## Greater Geelong Amendment C375 Panel questions & Council officer responses 30.8.2018

### Panel questions – Day 1

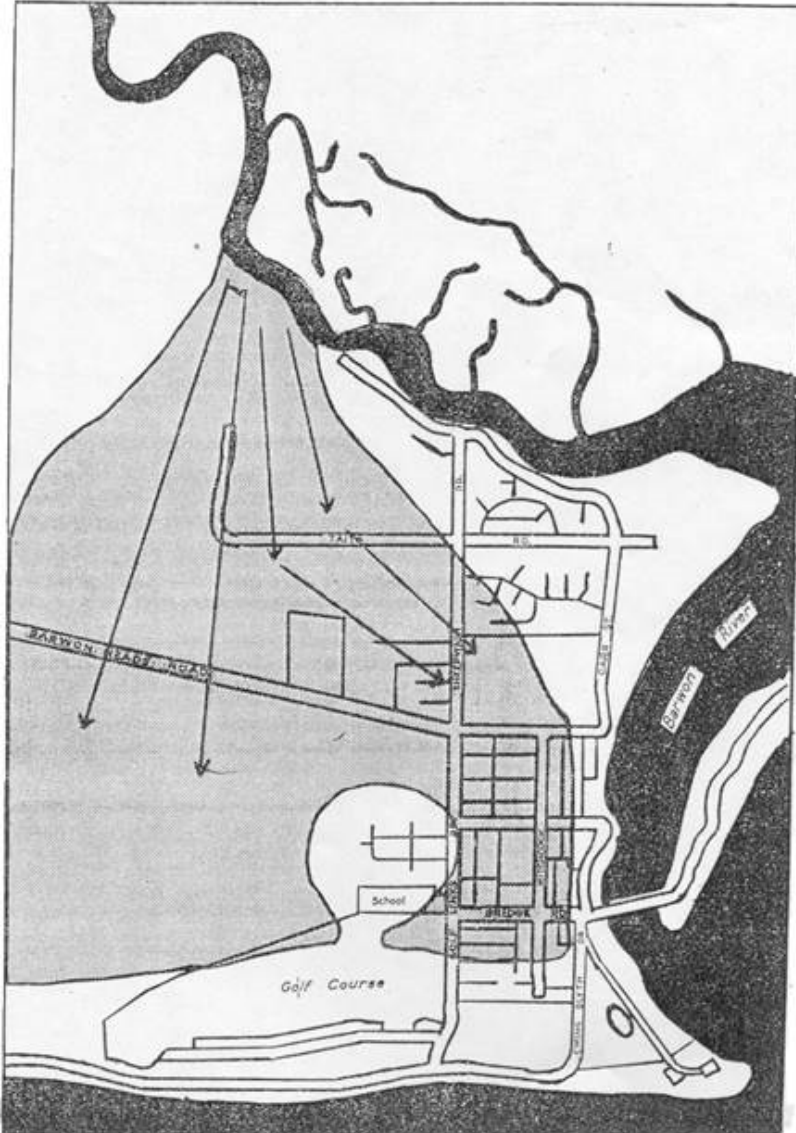
- Can we provide maps showing drainage patterns and flows?

Our Engineering Services have provided a map (**attached**), which attempts to show drainage patterns within Barwon Heads.

With respect to the map, they advise as follows:

- LiDAR DEM is colour ramped from low (white) to high (red)
- Flood extent is that currently designated as flood prone land for the purposes of Building Regulation 802. These have come from a variety of sources including:
  - Flood study / hydraulic modelling
  - Observation
  - Flood data transfer (DNRE, 200)

It must be noted the whole township has not been studied, and some extents have been 'squared up' to align with cadastre.

- Where not already identified as flood prone, it would be expected that water will pond in land with lower elevations (pinkish to white).
